Re: Broadcast District at Spring
Township
File #: 59-12129a
Plan #: 24401110 (64 Sheets of 67; 1-58,
and 62-67)
Dated: 11/15/24 with a revision 11/25/24
Prop ID #: 80 4397-10-46-8758

The Berks County Planning Commission staff has reviewed the Preliminary Plan as submitted for the above captioned land development and subdivision. The tract is located along the northeast side of the Paper Mill Road (S.R.3021) and Broadcasting Road intersection.

SHEET NO. 1001

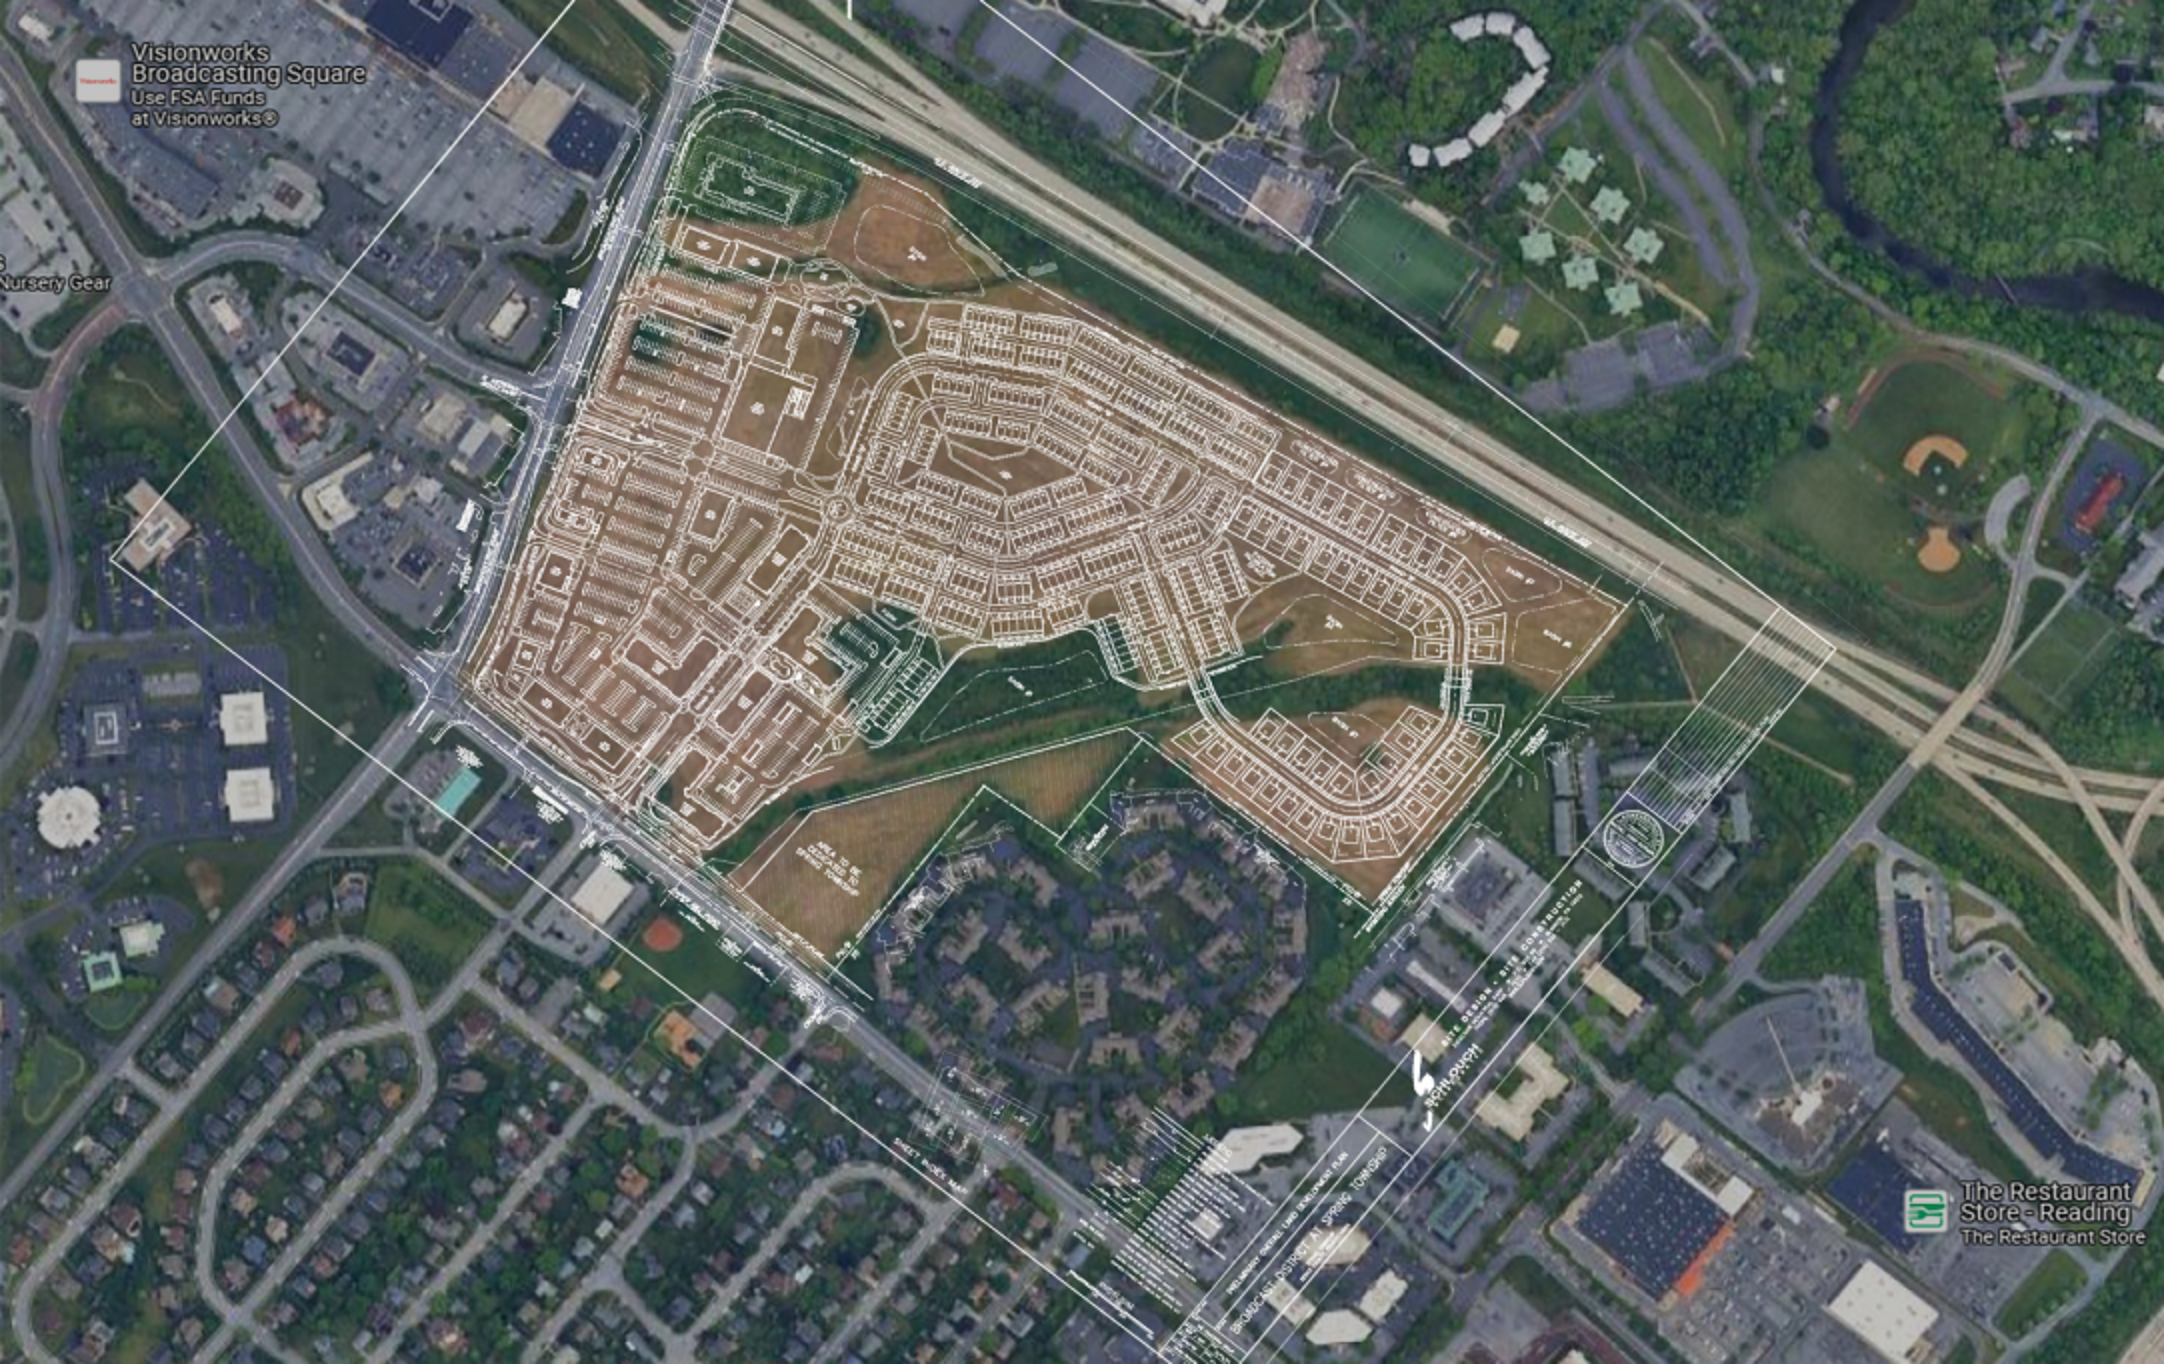
5. The section of Road 'B' in the proposed Lot 6 (single-family section of the development) identifies "No Parking" along the inside curve of the street. Will parking be allowed along the outside curve of this section of Road 'B'?

6. Consideration should be given to providing signage along Alley 'B' to indicate the 'No Outlet' at the southern end of the alley.
7. Consideration should be given to providing a 'No Parking' sign at the turn around area at the southern end of Alley 'B', at the bollards.

8. Consideration should be given to providing a 'Stop' sign at the Alley access to Road 'B', next to townhouse unit 223.
9. The alignment of the Alley 'A' and Alley 'B' intersection (end units 19 and 20 and 88 and 89) should be reviewed for appropriateness.

21. Consideration should be given to providing a Phasing Plan for the development of the site.
22. Consideration should be given to realign the proposed lot lines around the proposed 'Event Lawn/Play Area/Outdoor Fitness Area' so it is entirely located in Lot 8 rather than Lots 1, 7, and 8. Consideration should be given to adding additional play areas to the residential areas to accommodate the residents.

23. The site is adjacent to Wyomissing Borough. Wyomissing Borough should receive copies of all plans, related correspondence and reviews for its information and consideration and as a matter of courtesy.

26. Consideration should be given shifting the retail Buildings 300 and 400 closer to Broadcasting Road and removing the proposed parking spaces and drive access in order to provide a straight access drive to the proposed Lot 7, the proposed hotel site, in lieu of the indirect route needed to reach Lot 7.

35. Consideration should be given to providing bicycle racks and/or lockers at the apartment buildings.
36. The 'No Parking' symbol in the middle of the Road 'B', at unit 324, should be removed.
